Pedestrian Mobility and Safety Audit **Phoenix, AZ, USA**

Executive Summary

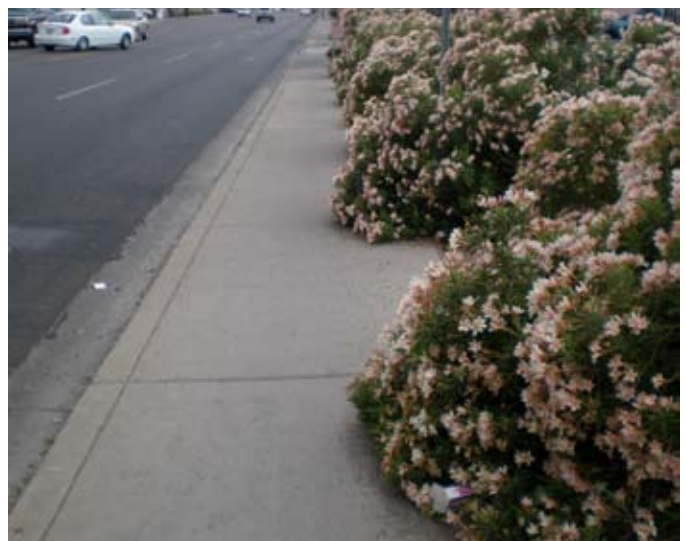
In the short-term, the following recommendations should be considered to improve the safety of the intersection:

- **Replace** the existing incandescent pedestrian signal indications with LED countdown signal indications.
- **Trim** landscaping on the southwest corner that is encroaching into the sidewalk area.

- **Install** detectable warning surfaces to enhance the safety for visually-impaired pedestrians.
- **Remove** other obstructions that impede pedestrian traffic.
